CITY OF MADERA PLANNING COMMISSION

Staff Report: Caliber Collision CUP 2019-12, SPR 2019-19 & Categorical Exemption Item # 4 – September 10, 2019

PROPOSAL: Consideration of a request for a conditional use permit and site plan review to allow for the establishment of an auto body repair shop with overnight on-site parking in conjunction with the development of a 10,000 square foot premanufactured building.

SITE PLAN SCALE: 1" = 20'-0"

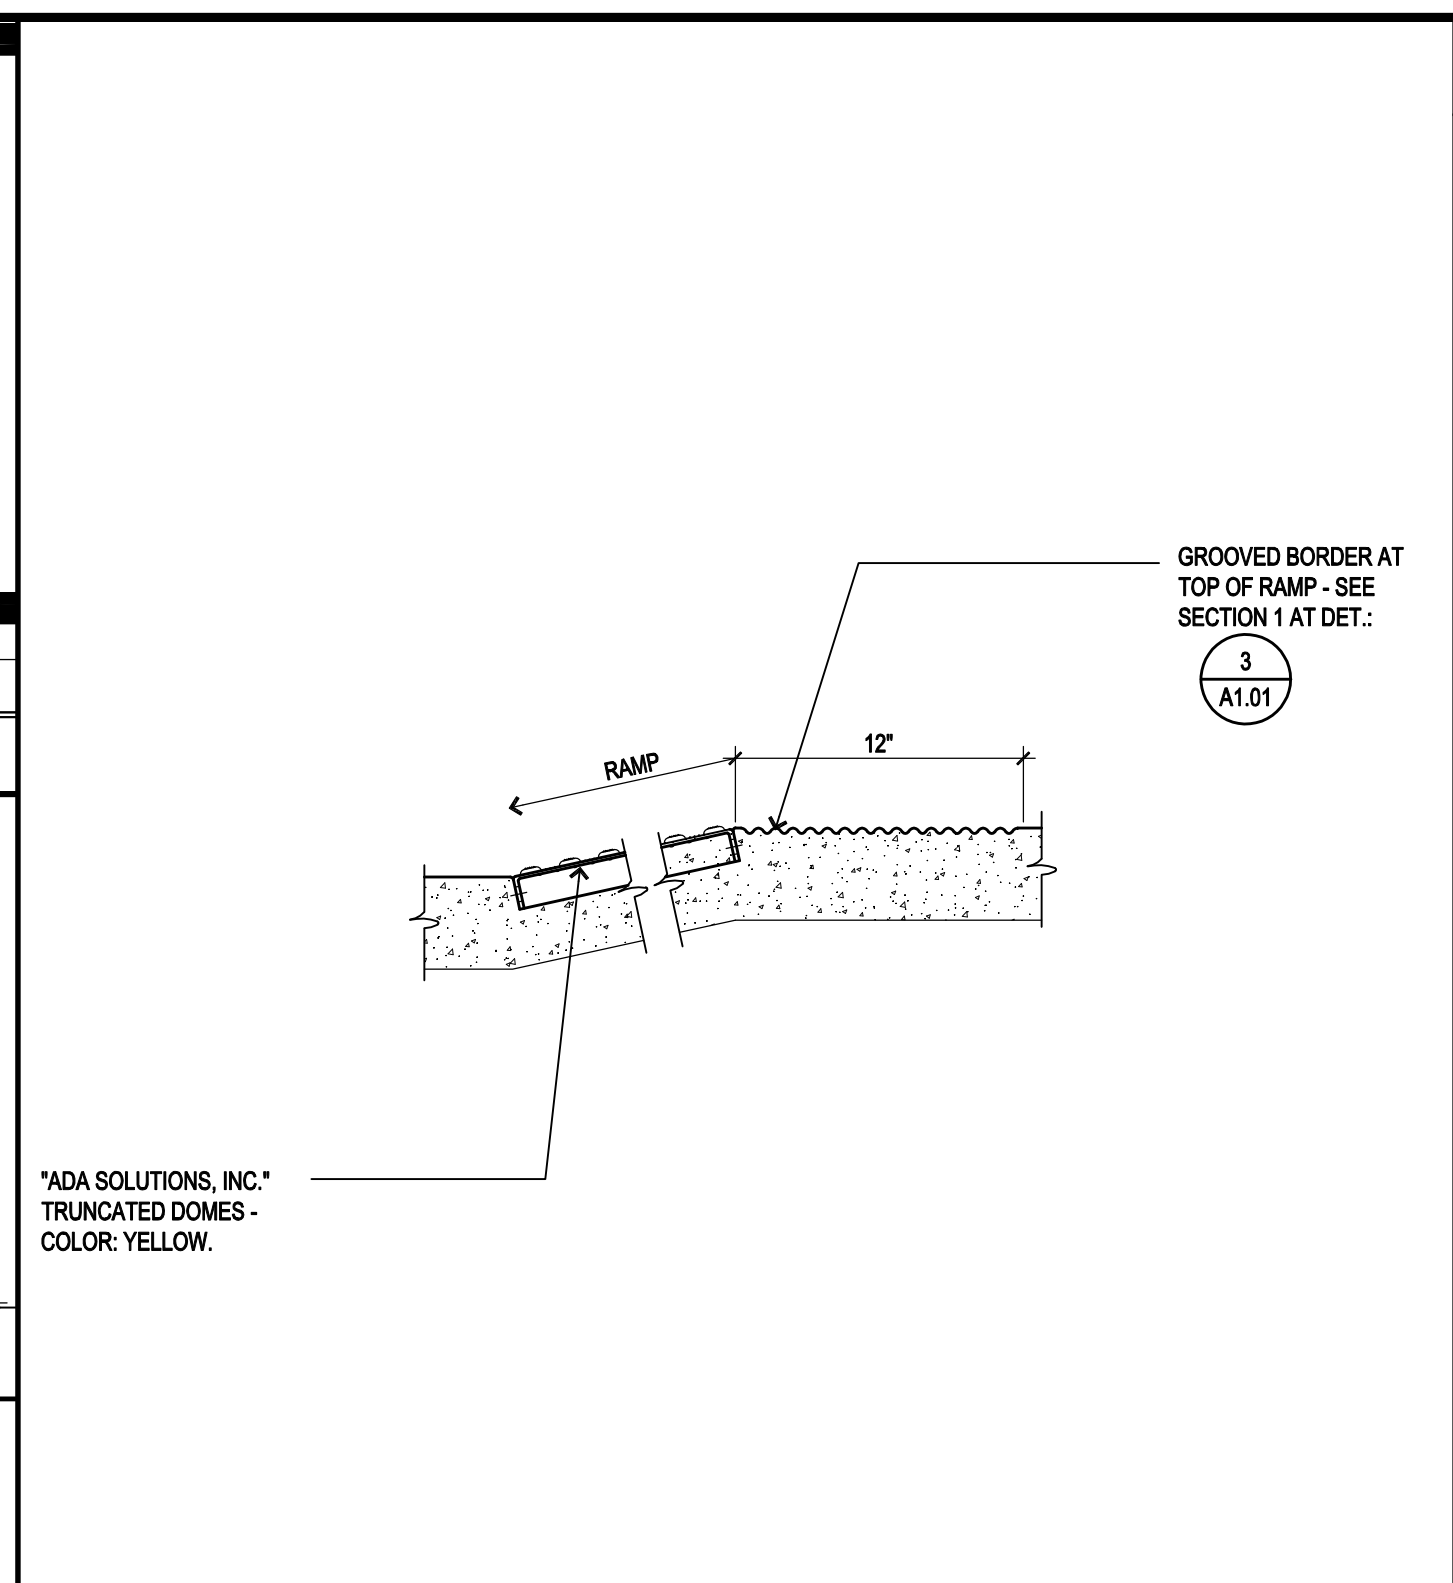
landscape architecture including, but not limited to, human-scale design, pedestrian orientation, interconnect of street layout, siting buildings to hold corners, entry ways, gathering points and landmarks". The building proposal holds the corner with a pedestrian-oriented patio area for customers and employees. The site design, however, does not aspire to the highest-quality urban design omitting architectural features and/or design cues that provide an overall visual interest to the site. Cumulatively, site design is minimal considering the project site is broken up by parking and a metal premanufactured building.

The site design provides a building presence along street frontages while minimizing the presence of parking areas as the primary visual feature. On-site parking is only visible from the West 8th Street entrance onto the site. The parking lot is also designed to allow for proper circulation with the southern adjoining property and the existing Caliber Collision property. This design is consistent with Policy CD-15 which states, "except where site conditions make it infeasible, new commercial development[s] shall be designed to front or have a presence along all street frontages. The intent of this policy is to enhance the pedestrian scale of new development, and minimize the presence of parking, circulation, and loading areas as the primary visual features of development".

The site proposal includes a fence with gates into the parking lot and the outdoor patio area for security purposes as part of the request for on-site overnight vehicle parking. The material type and design of the fencing is required to be consistent with the overall visual/architectural design of the site as indicated in Policy CD-17, which states the "use of security fencing, window barriers, or similar features are necessary to secure a building or site, these measures shall be incorporated into the visual/architectural design of the project and shall be complementary to surrounding uses...". The applicant has not specified the fence material, making it difficult to discern whether the fence will contribute to or diminish the overall site/architectural character. Uses such as auto body repair and auto detailing that require overnight parking usually provide vehicle parking within the interior of the building. The proposed building has considerable interior vehicle storage for approximately ten standard parking stalls. Consequently, staff would recommend overnight parking only occur within the interior of the building, rendering the need for a security gate and fence unnecessary. In either case, staff would not be in support of the fence without confirming the material type prior to its placement.

The City's parking standards for an auto body repair shop requires one parking stall for every 400 square feet of gross floor area, plus one space for every two employees. This would equate to a parking requirement of twenty-nine parking stalls; twenty-five for the building gross floor area plus four additional parking stalls for the anticipated eight employees. The development is proposed with twenty-two stalls within the outdoor parking field. Noting that the use entails queuing customer vehicles within the building, the structure could have more than ample floor area to accommodate, at a minimum, the seven additional stalls necessary to provide the required twenty-nine on-site parking stalls. Required handicap parking would be provided. Cumulatively, there is adequate parking to serve the proposed auto body repair business expansion. The parking field east of the structure satisfies General Plan policy CD-57, which encourages parking lots to "be located behind or on the side of the buildings to reduce their visual impact."

Landscaping is provided between the sidewalk and the structure and throughout the parking field which reduces the footprint of paved areas and segregates the parking field into smaller components. The overall design of the landscape is in conformance with General Plan Policy CD-58, which requires that “parking lots shall be screened and separated into smaller units with landscaping or low walls”. Tree plantings should also result in better shade coverage to the parking field. A landscape and irrigation plan compliant with the California Model Water Efficient Landscape Ordinance (MWELO) would be required to be submitted for review and approval by the Planning Department.

Site design is mostly conforming with the applicable goals and policies. Staff recommends the security gates and fencing be constructed of a higher quality that is aesthetically pleasing and compatible with the site design. Landscape design would also be paramount to the site’s aesthetic value. Parking areas would be required to be maintained and kept clear of any blight including unpermitted car structures, repair equipment and/or auto body repair parts.

Attachment 3: Floor Plan / Elevations

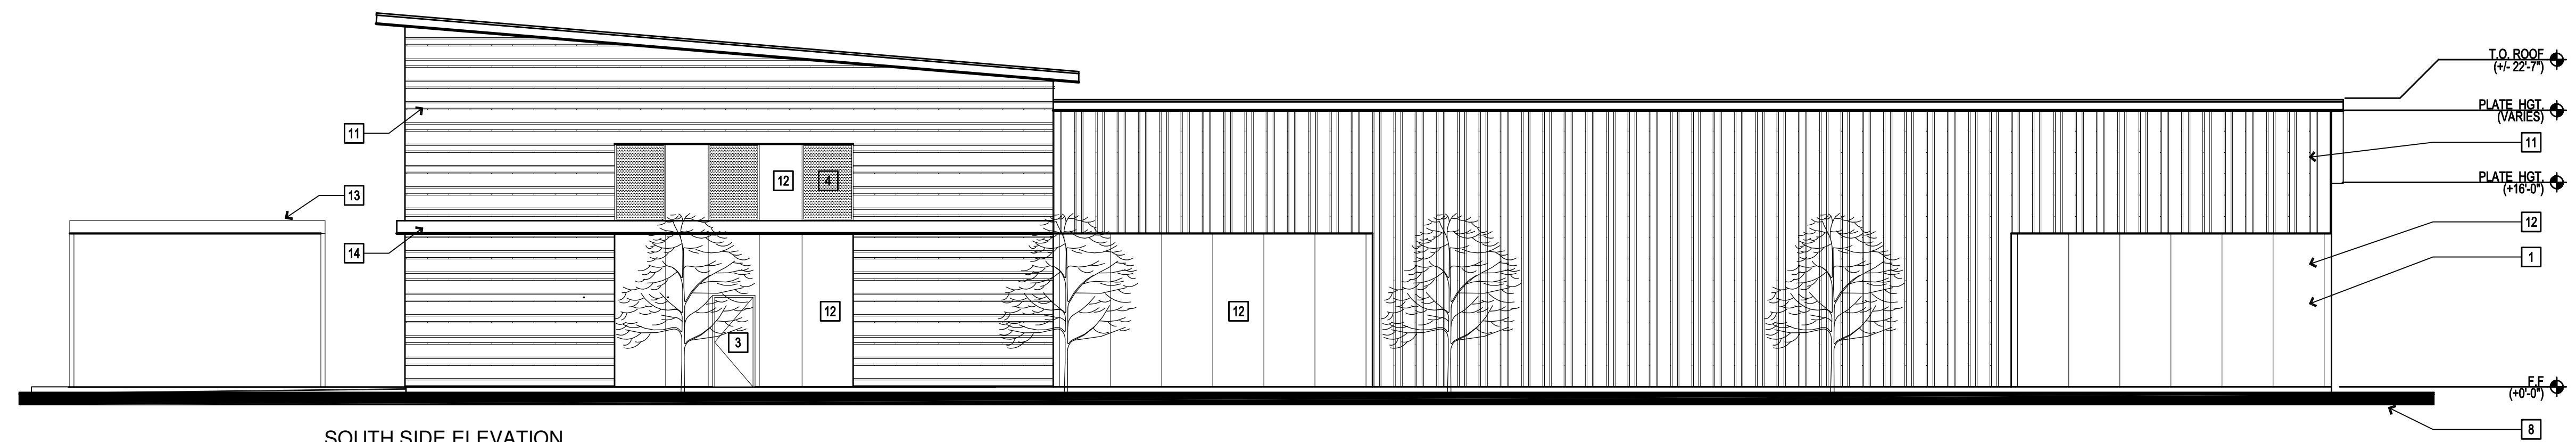
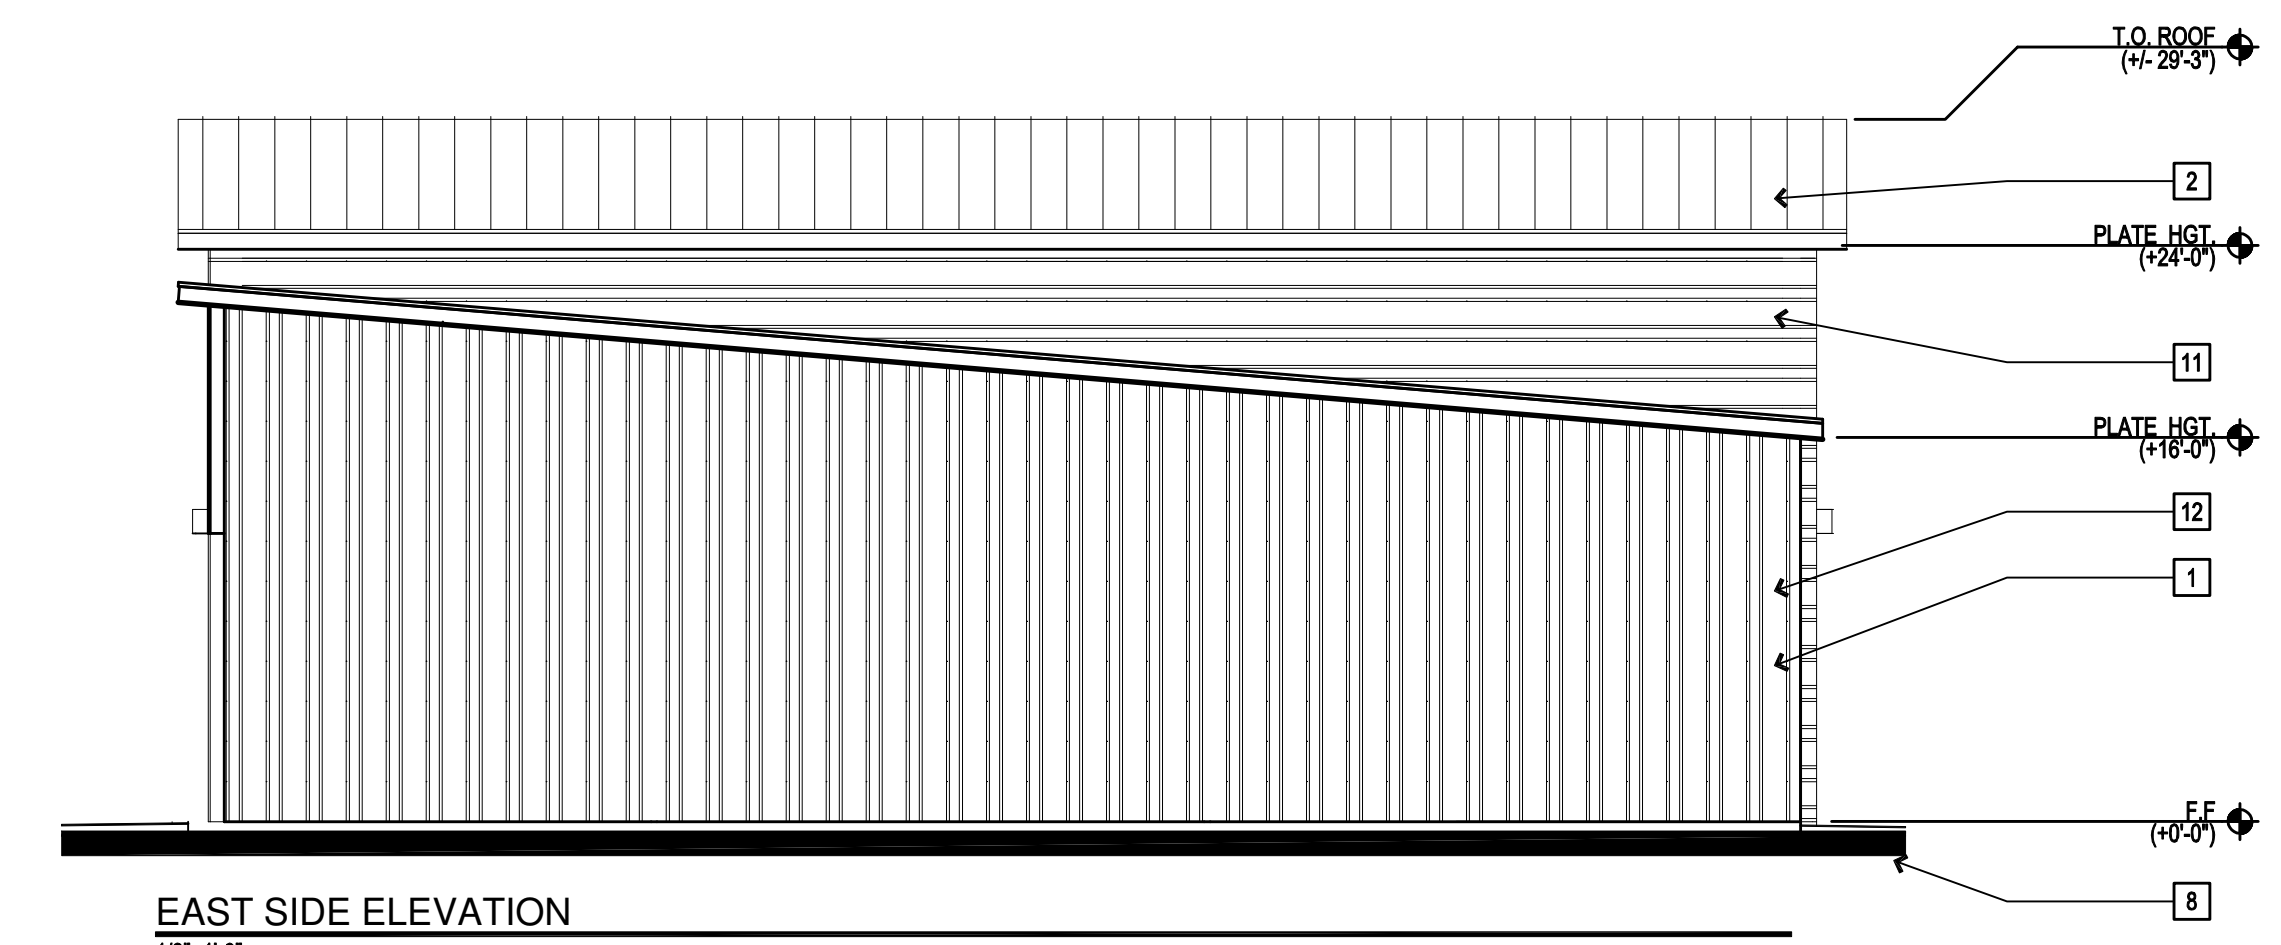
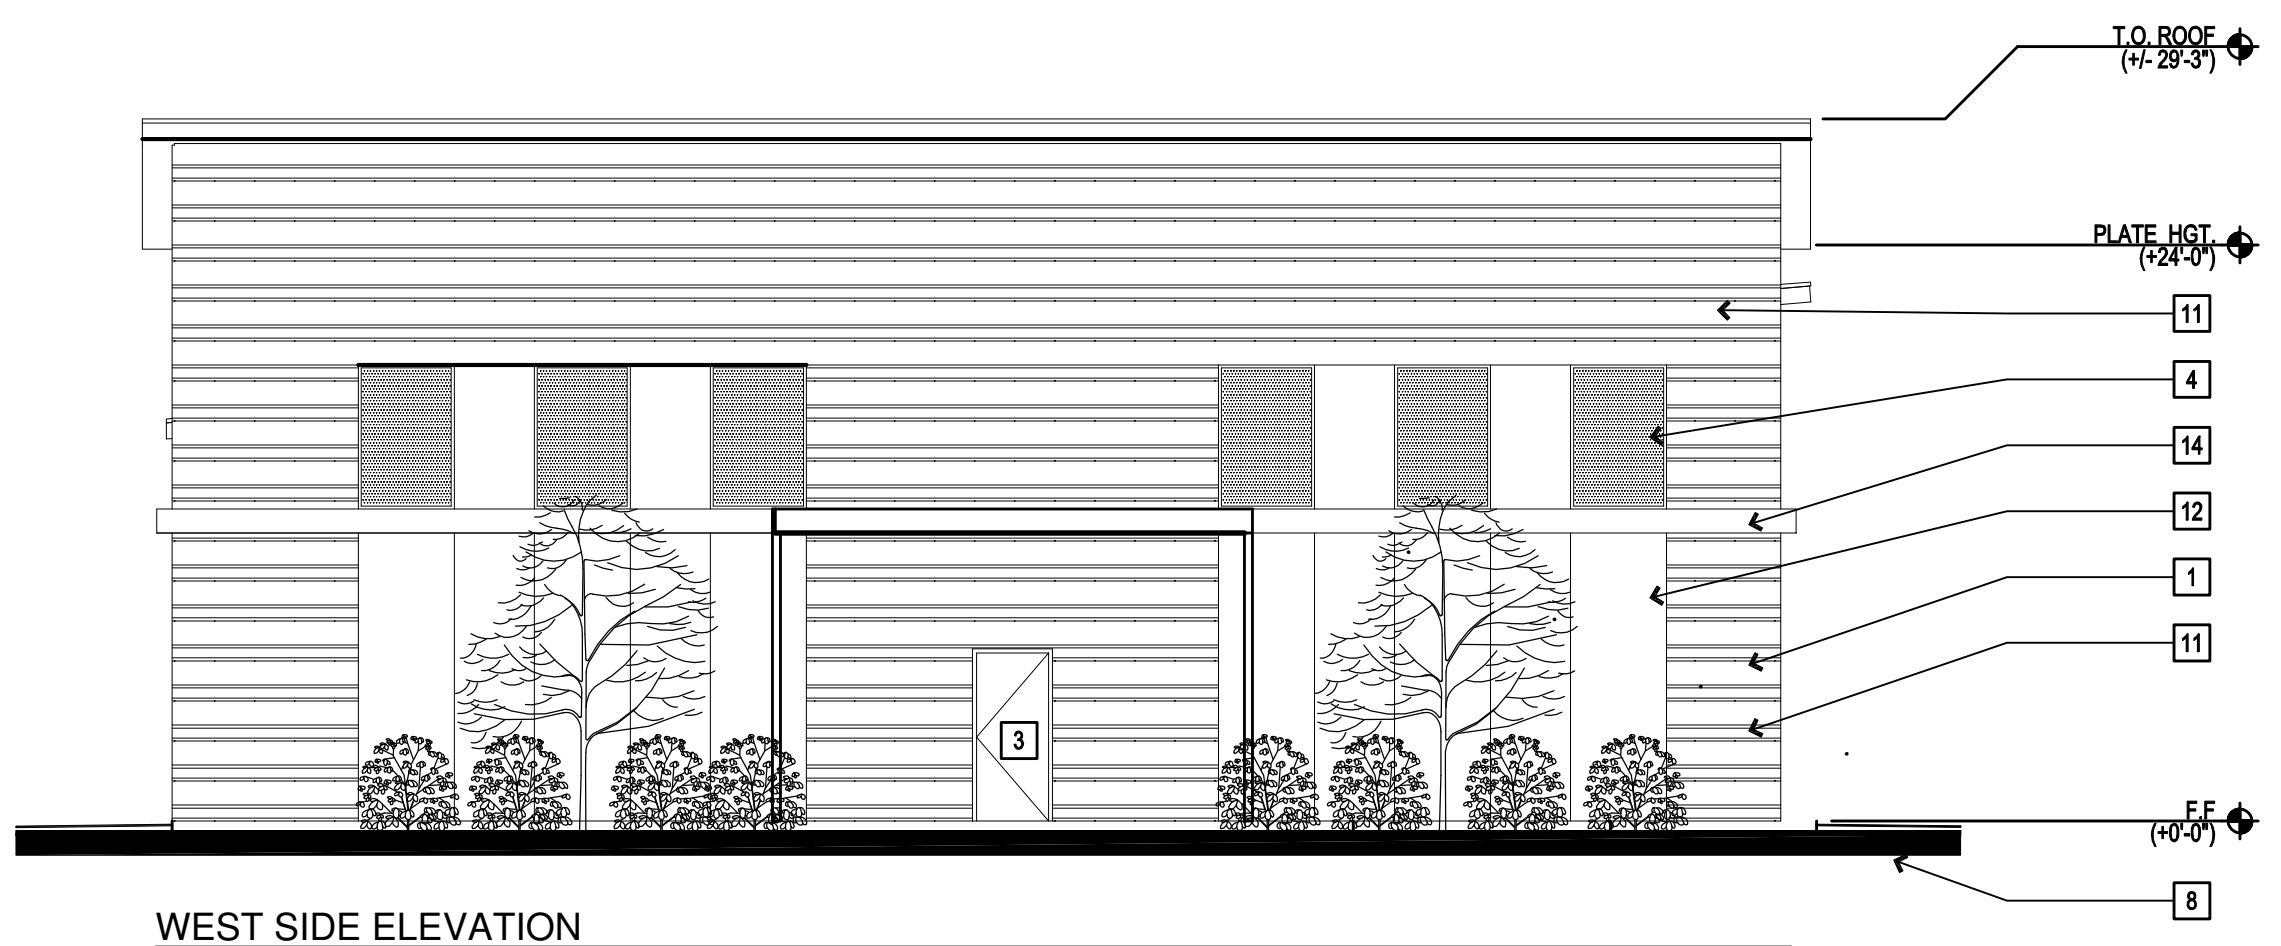
As proposed, the premanufactured metal building does not provide conformance with Goal CD-12 (Aesthetically Pleasing Commercial Development), of the General Plan. The unarticulated, boxy structure is comprised of three metal exterior materials designed to provide partial surface variation. Raised windows have been added as a component of the design. Cumulatively, the exterior building design is stark. Varied metal types are present on the building's northern elevation and on approximately a third of the western elevation. The southern and western building elevations propose a metal exterior without any articulation or architectural features. Per Policy CD-53, the proposed building is expected to be "broken up by creating horizontal emphasis through the use of trim, varying surfaces, awnings, eaves, or other ornamentation, and by using a combination of complementary colors". The applicant ultimately opted to rely on a "standard design" of the premanufactured building proposing no structural additions that improve its architectural quality. This standard-design contradicts Policy CD-3 which states the City "will strive to continuously improve the architectural quality of public and private projects. Developers proposing to rely on the use of "standard designs" or corporate architecture" will be required to improve the designs as necessary to meet the City's overall standards for quality". As a rule, metal shed architecture is not supported in commercial zones of the City. Approval of a metal building sets a dangerous precedent that could lead to further requests for metal sided

structures and the erosion of the built environment. As such, staff is not able to make general plan conformance findings commensurate to Policy CD-3 and 53.

Noting that the project is proposed as an extension of an existing business use on an adjoining property, the proposal is not “linked visually through architectural style, colors, materials, signage, landscaping, design details such as light fixtures, and the use of arcades, trellises, or other open structures”, per Policy CD-52. The only linkage between the two buildings would be the exterior metal building material, with no other architectural similarities between the two buildings.

The applicant has stated the proposed building’s architectural design is an improvement from the existing Caliber Collision building. Staff’s analysis identified two critical components that refute the idea that the proposed building will be an improvement from the existing building, First, the existing Caliber Collision building was constructed prior to the 2009 General Plan update and approval of the 2009 Design and Development Guidelines. The existing structure and site plan were reviewed under different development guidelines that applied admittedly lower standards. Second, as a condition to the originally approved site plan review, the original entitlement benefactor was required to provide revised plans with improved exterior elevations. Even as proposed in 2000, the building façade was considered insufficient within a commercial zone along a primary commercial arterial street.

None of the recommended embellishments were incorporated into the final building design. No false pillars were constructed to provide articulation and connectivity to the stucco components of the front fascia. What revision that ultimately were made resulted in a building with minimal horizontal height variation, only stucco on the front of the structure, window awnings on the front elevation and an unattractive metal mansard roof element on much of the visible elevations. Though the existing Caliber Collision building may include some desired architectural features as stated in the Design and Development Guidelines, it does not have approvable elevations by the current General Plan standards. Staff advises against using the existing Caliber Collision building as a nexus to approve the proposed building. Both the existing and proposed elevations are not consistent with General Plan goals and policies.

But, the proposed building is a stark metal “box”. The building lacks articulation, varied surface materials and the use of architectural detailing. Although the placement of raised windows in conjunction with the use of a metal trim provides for a break in the mass of the northern elevation, no additional treatments are provided on the other three building elevations. Overall, the architectural design and construction quality of the building proposal provides a low-quality design not supported within any commercial zone. Additional exterior treatments and alternative building materials can be utilized to change the elevations commensurate with Policies CD-52 and 53.
